**CITY OF SULLIVAN, MISSOURI
AND
SULLIVAN REGIONAL AIRPORT**

ADDENDUM NO. 1

State Project No. 18-112B-1

CONSTRUCT 4-UNIT T-HANGAR AND 6-UNIT EXECUTIVE T-HANGAR

18-112B-1
Sheet 7 of 34
Drawing: C-1100
VOL. 1 of 1

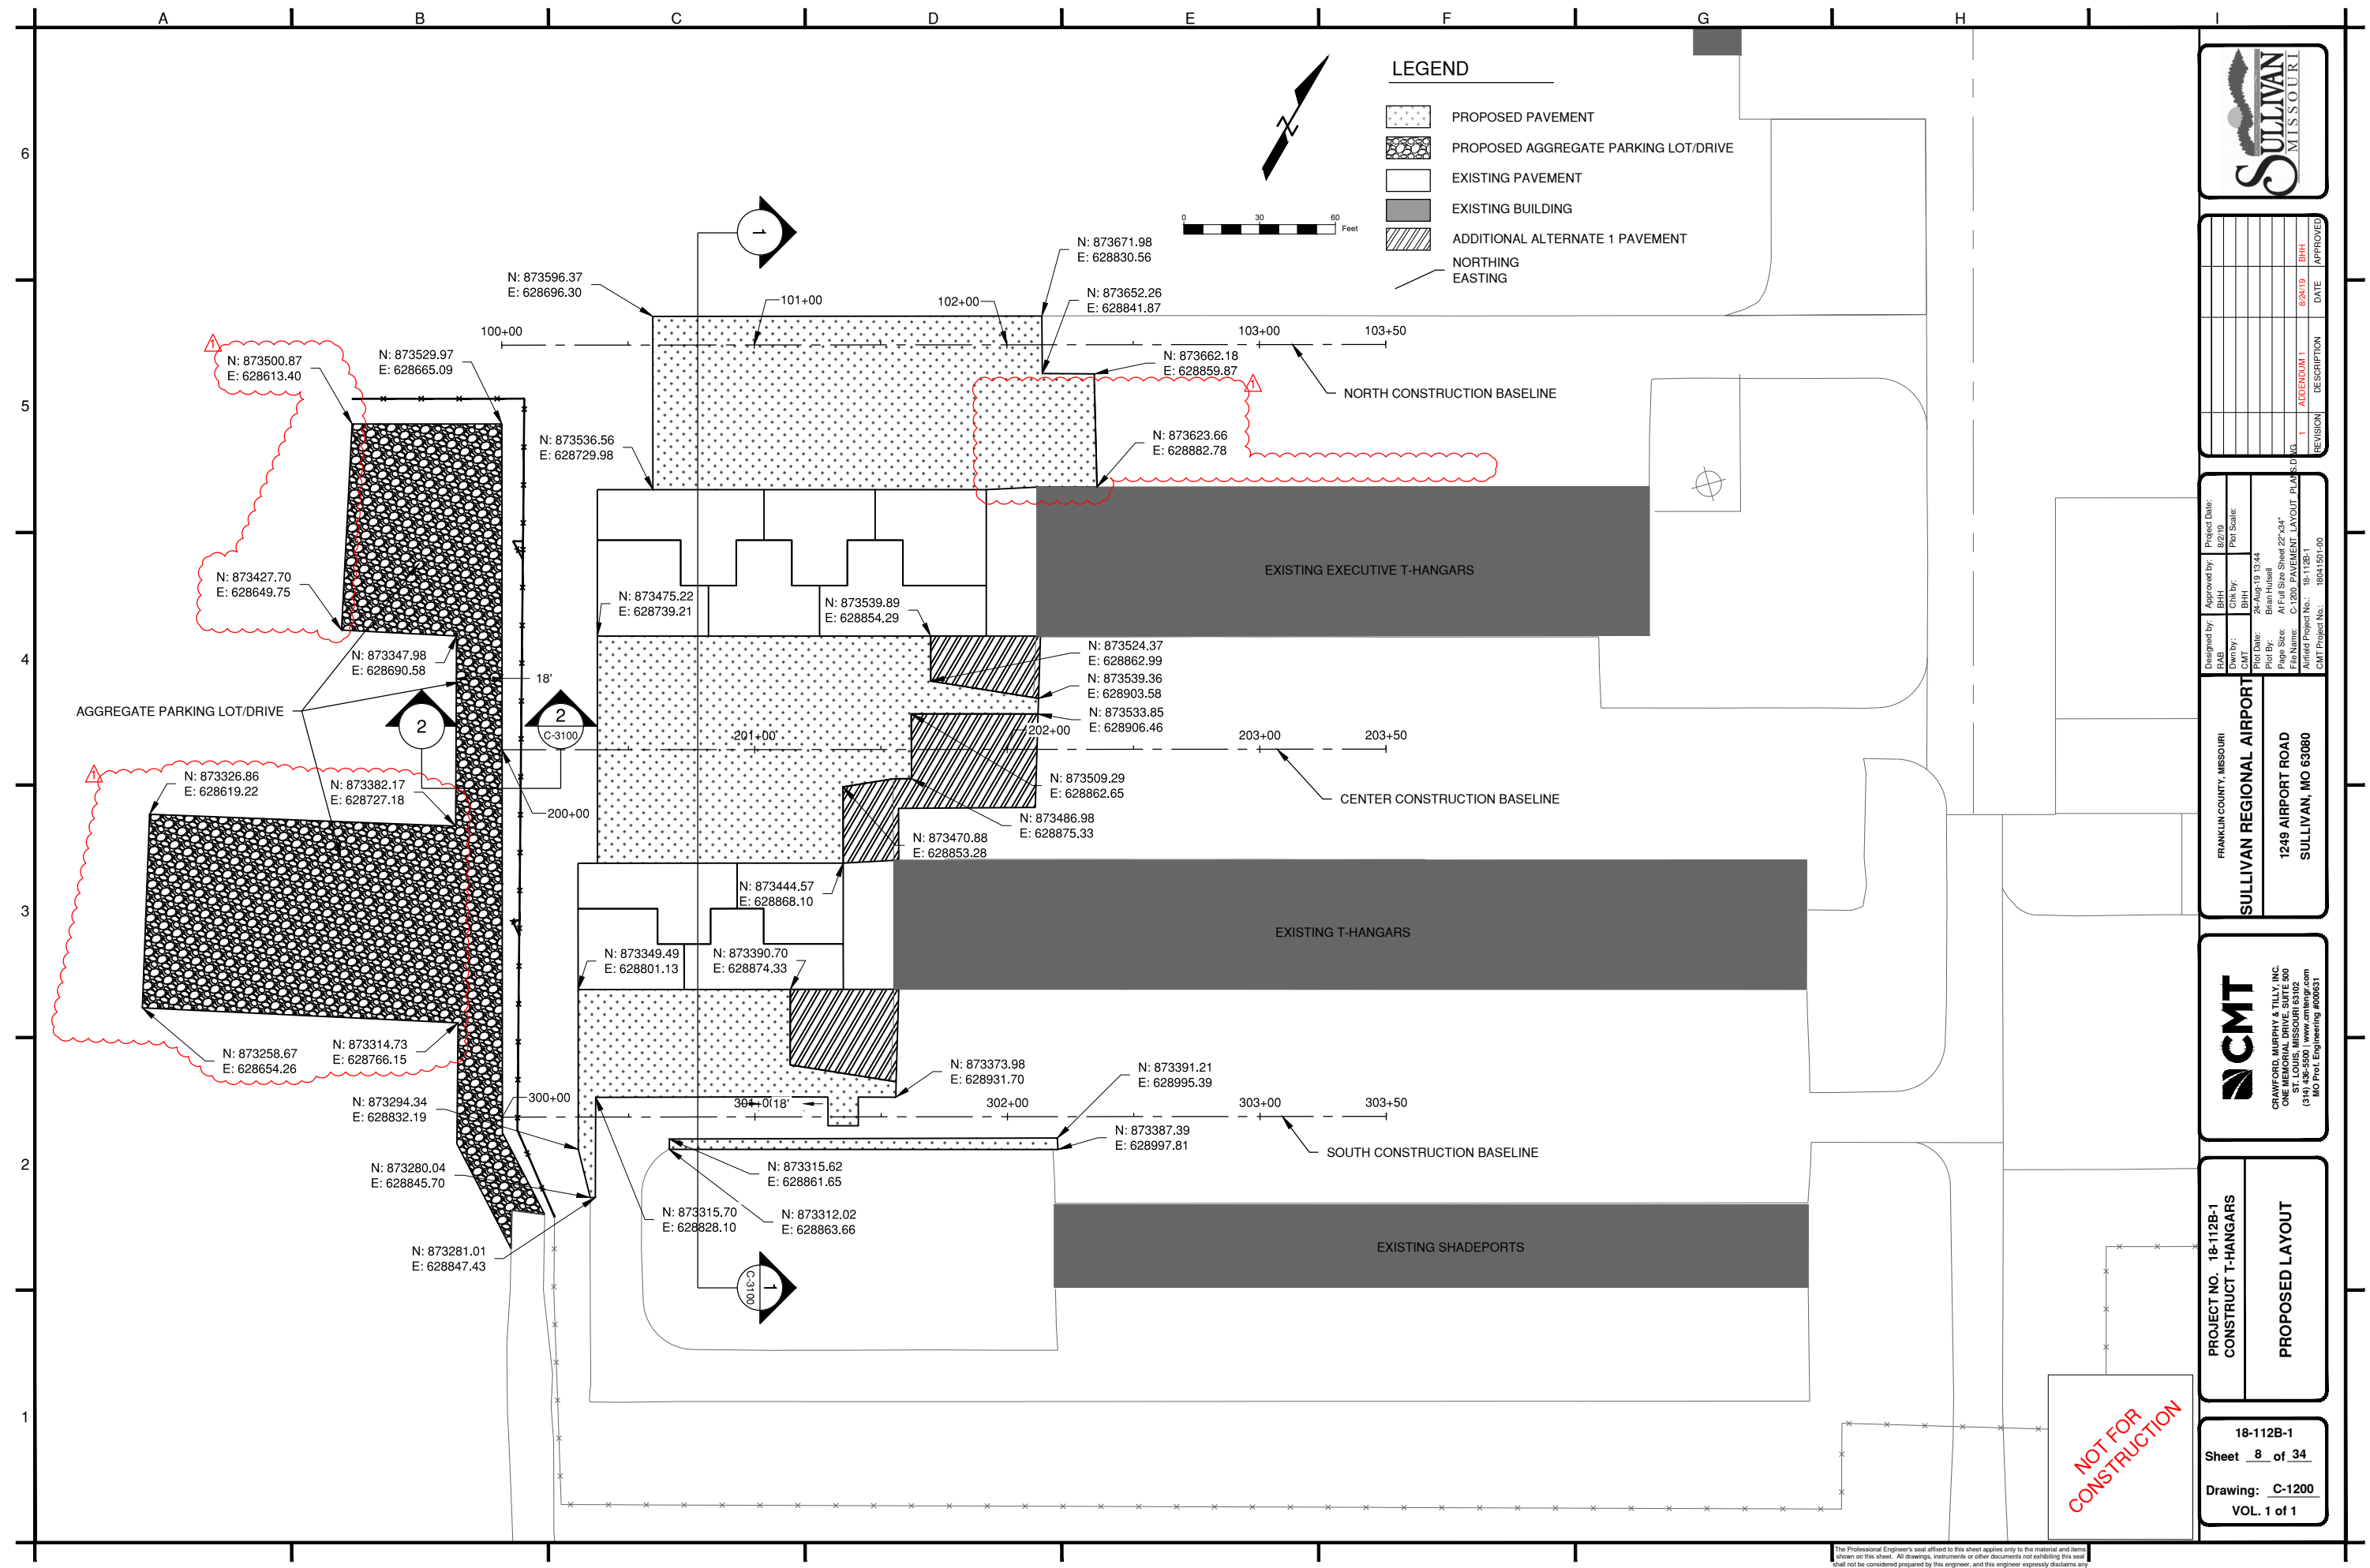
Sheet 7 of 34, DEMOLITION PLAN

CLARIFICATION: Pavement removal associated with northernmost alternate 1 pavement shifted to the base bid.

18-112B-1
Sheet 8 of 34
Drawing: C-1200
VOL. 1 of 1

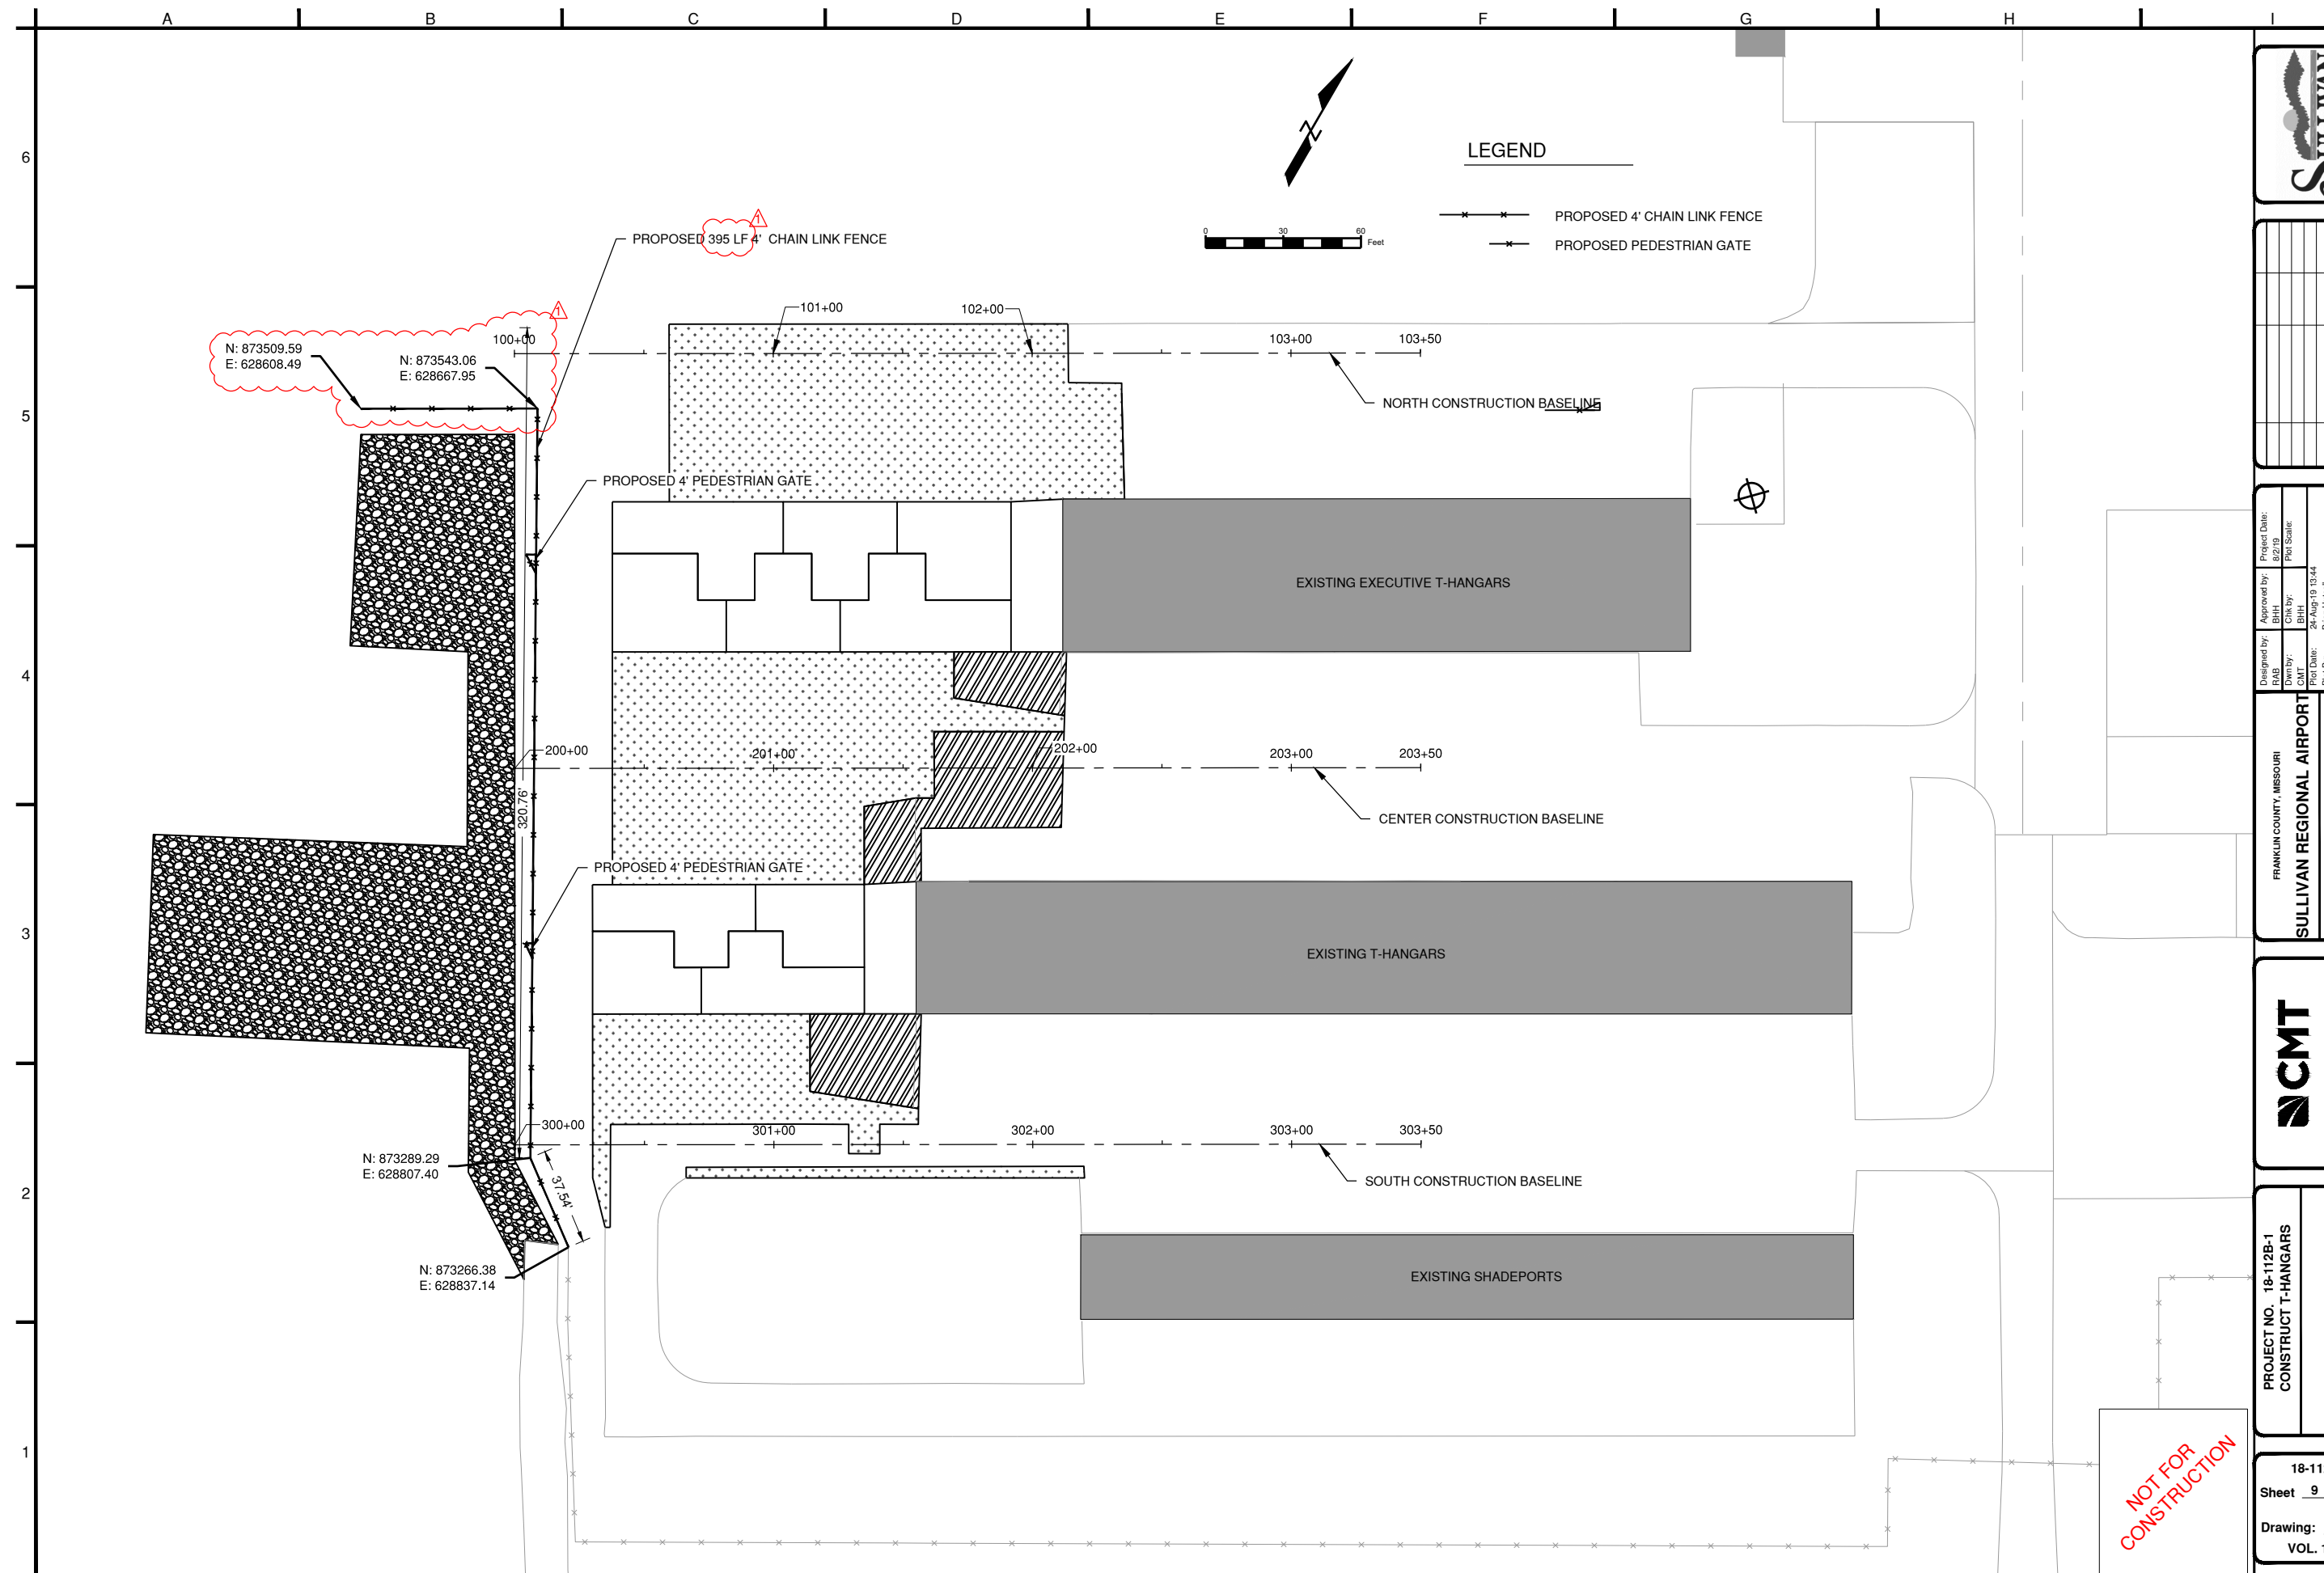
Sheet 8 of 34, PROPOSED LAYOUT

CLARIFICATION: Northernmost Alternate 1 pavement area shifted to the base bid. Gravel parking areas reduced in size.

18-112B-1
Sheet 9 of 34
Drawing: C-1201
VOL. 1 of 1

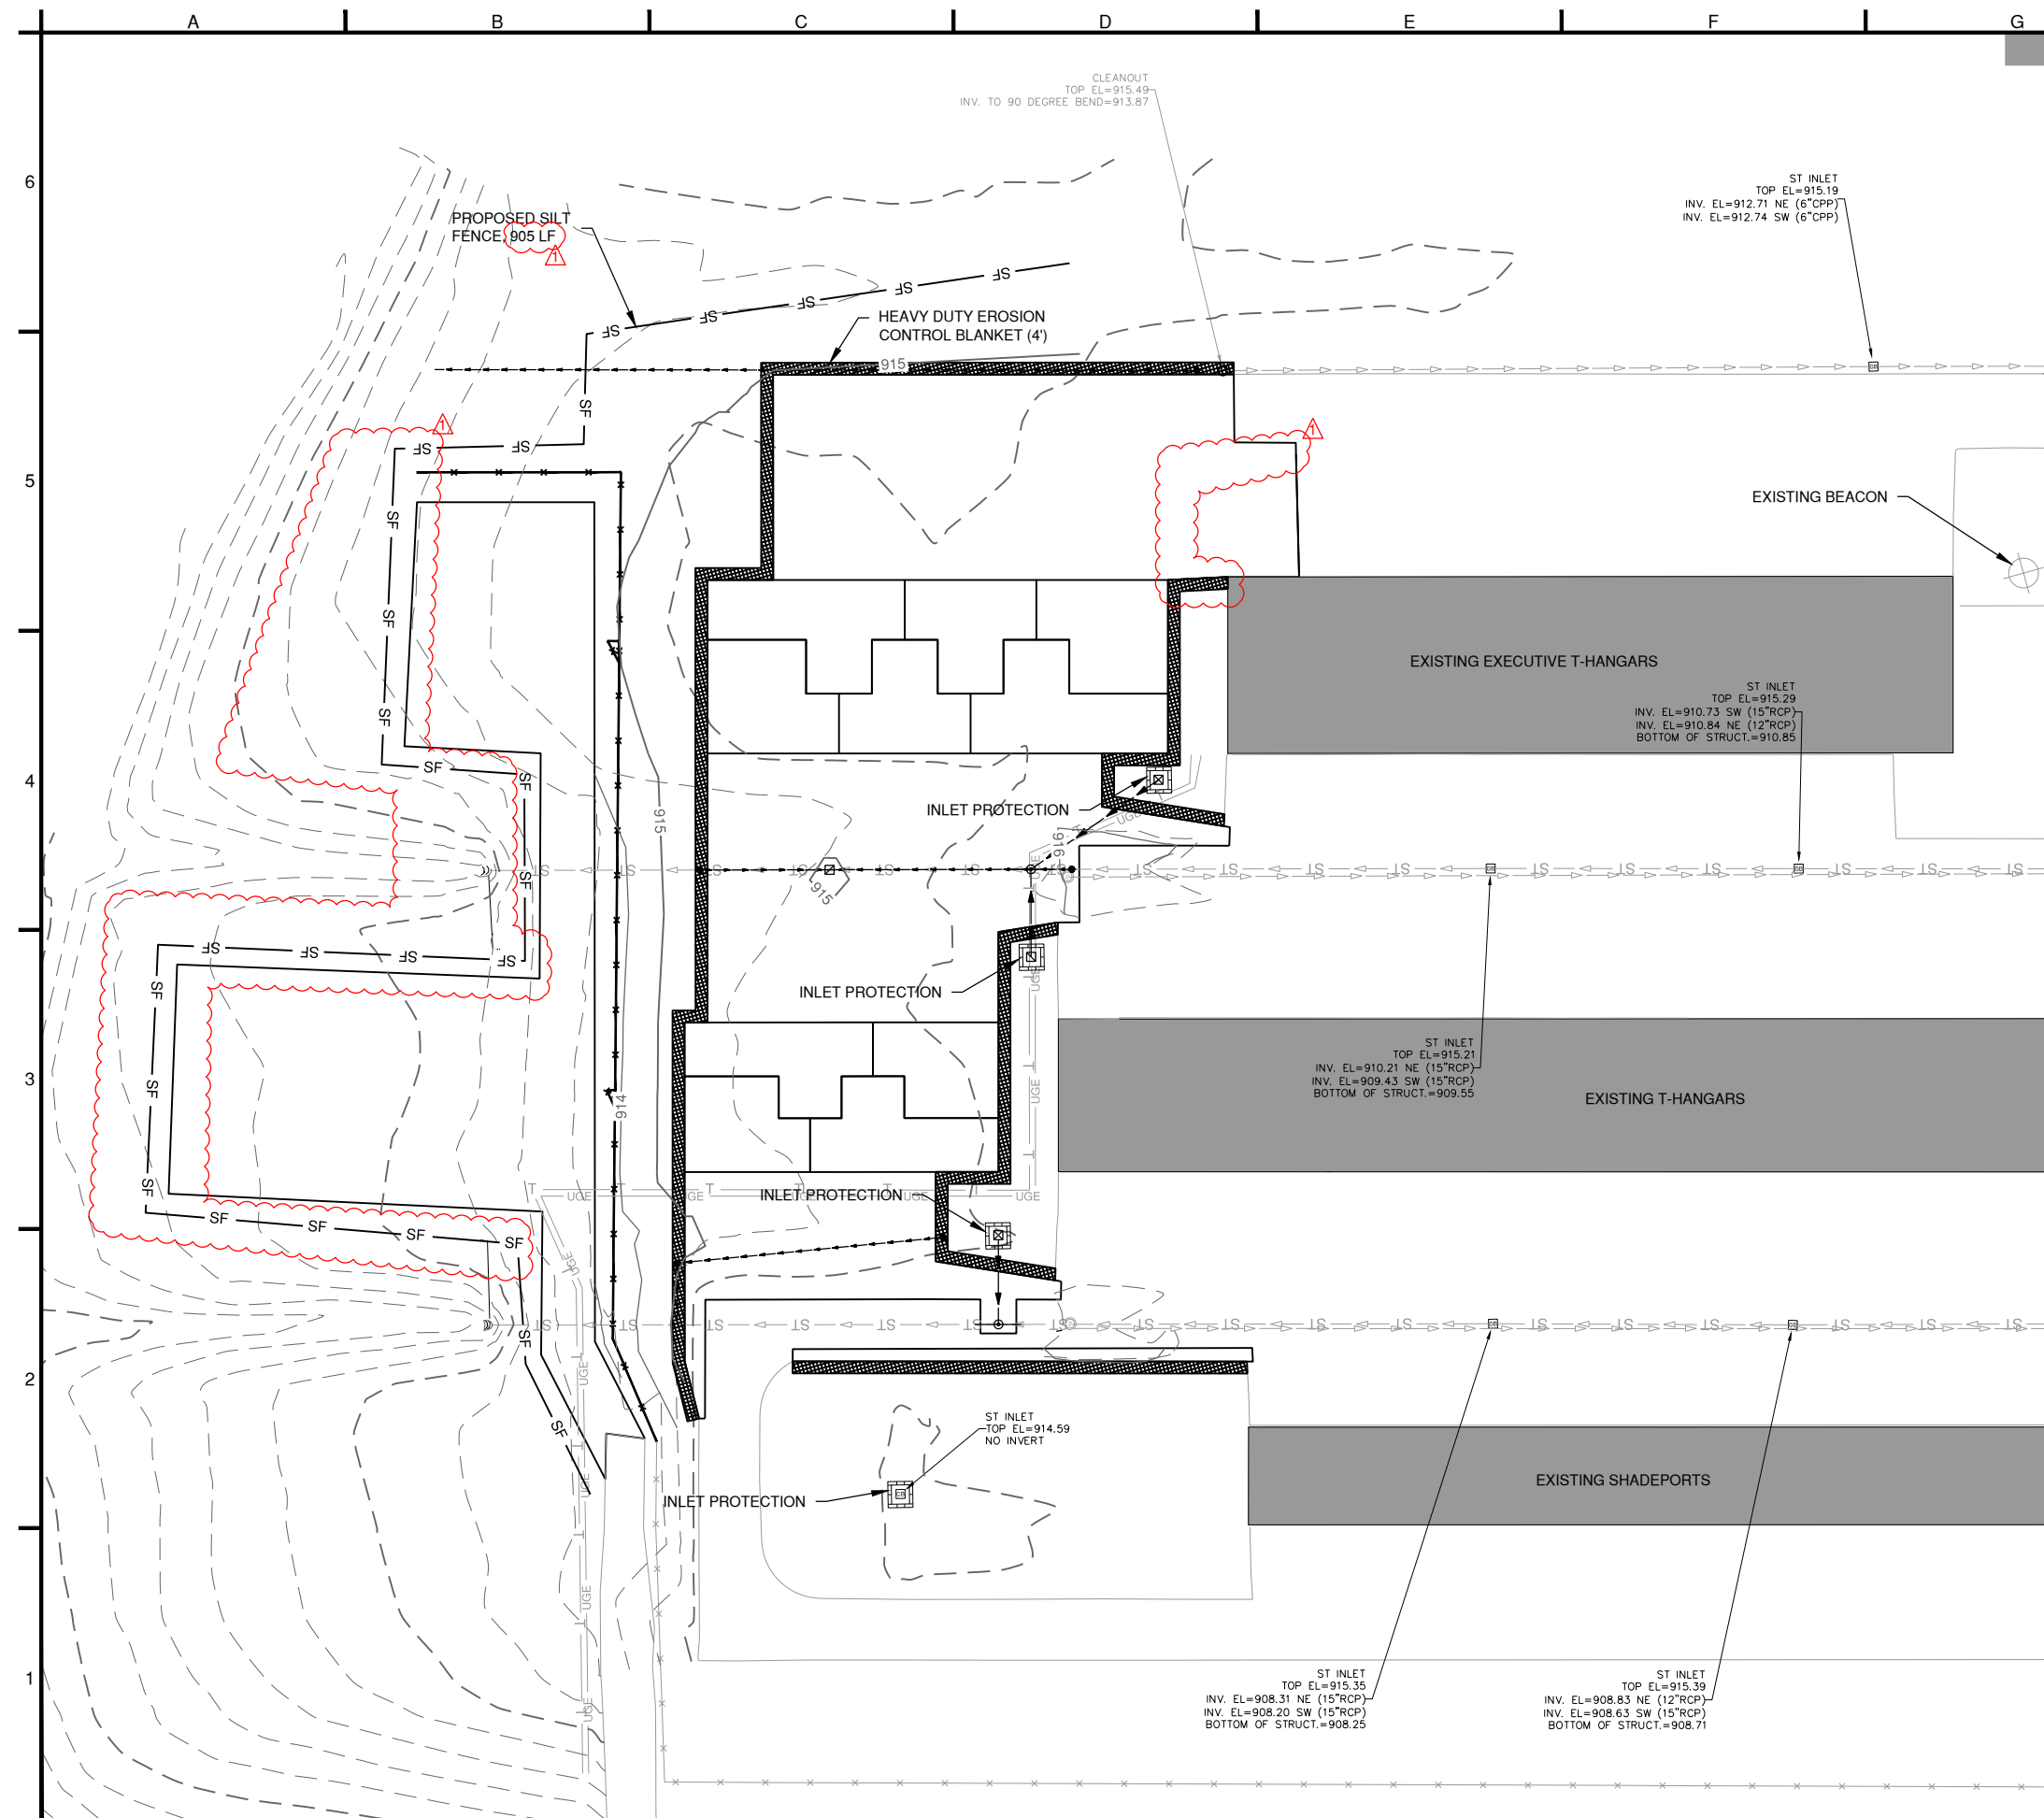
Sheet 9 of 34, FENCE LAYOUT

CLARIFICATION: Chain link fence layout revised at north end.
